## **HOLDOVER**

# **DAWES HEIGHTS SUBDIVISION, RESUBDIVISION OF LOT 1**

APPLICATION NUMBER Holdover DATE January 6, 2004  
APPLICANT Dawes Heights Subdivision, Resubdivision of Lot 1  
REQUEST Subdivision

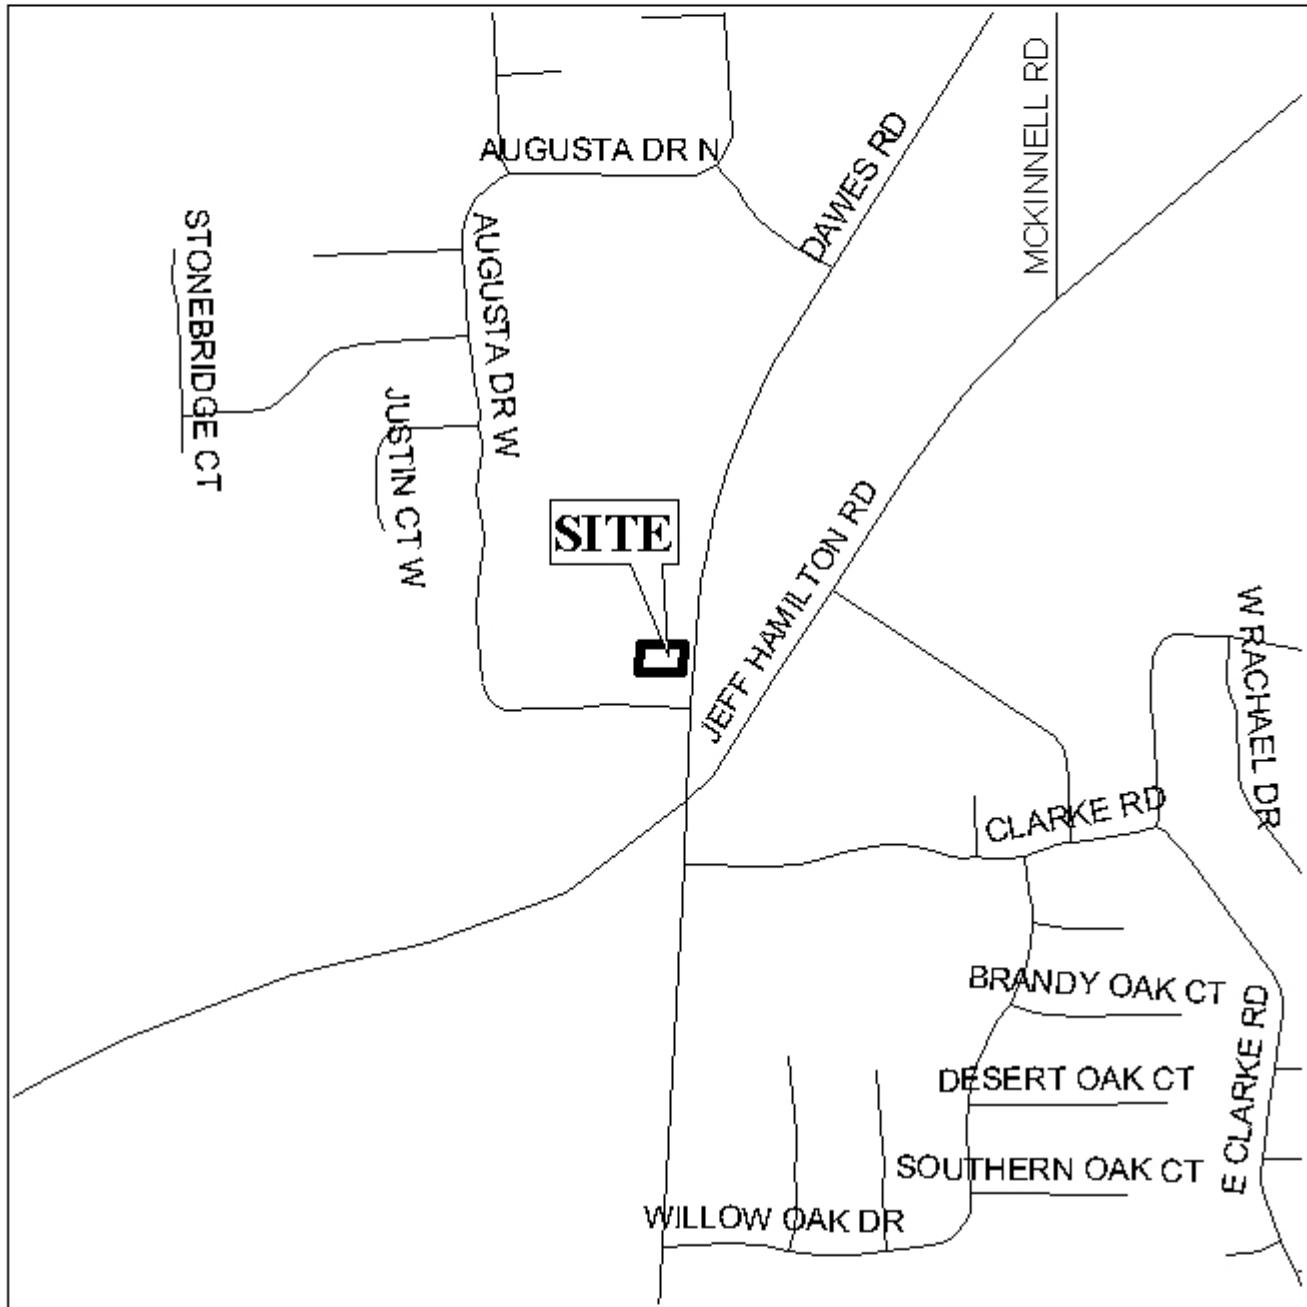
Engineering Comments: Must comply with the Mobile County Flood Damage Prevention Ordinance.

The site fronts Dawes Road, a planned major street and the existing right-of-way is shown as 80-feet; the Major Street Plan requires a 100-foot right-of-way. Therefore, the provision of a 75-foot setback (which includes the required 25-foot minimum building setback) from the centerline of Dawes Road, to provide for the right-of-way of the planned major street, should be required. Additionally, as a means of access management, the placement of a note on the final plat stating that Lots 1 and 2 are limited to one curb cut each to Dawes Road, with the size, location and design to be approved by County Engineering, should be required.

This site is located in the County, thus a note should be placed on the final plat stating that any lots which are developed commercially and adjoin residentially developed property must provide a buffer, in compliance with Section V.A.7. of the Subdivision Regulations.

With modifications, the plat will meet the minimum requirements of the Subdivision Regulations and is recommended for Tentative Approval subject to the following conditions: 1) the provision of a 75-foot setback (which includes the required minimum building setback of 25-feet) from the centerline of Dawes Road; 2) the placement of a note on the final plat stating that Lots 1 and 2 are limited to one curb cut each to Dawes Road with the size, location and design to be approved County Engineering; and 3) the placement of a note on the final plat stating that any property that is developed commercially and adjoins residentially developed property shall provide a buffer, in compliance with Section V.A.7. of the Subdivision Regulations.

*This application was heldover from the Commission's December 16<sup>th</sup> meeting until the January 6<sup>th</sup> meeting at the applicant's request. The applicant has submitted a revised site plan illustrating required building code setbacks between the two existing structures, a minimum of 25-feet of frontage for Lot 2, and adequate area for both lots. It should be noted that a waiver of Section V.D.3. (width to depth ratio) would be required for Lot 2. With modifications and a waiver of Section V.D.3., the plat will meet minimum requirements of the Subdivision Regulations and is recommended for Tentative Approval subject to the following conditions: 1) the provision of a 75-foot setback (which includes the required minimum building setback of 25-feet) from the centerline of Dawes Road; 2) the placement of a note on the final plat stating that Lots 1 and 2 are limited to one curb cut each to Dawes Road with the size, location and design to be approved County Engineering; and 3) the placement of a note on the final plat stating that any property that is developed commercially and adjoins residentially developed property shall provide a buffer, in compliance with Section V.A.7. of the Subdivision Regulations.*
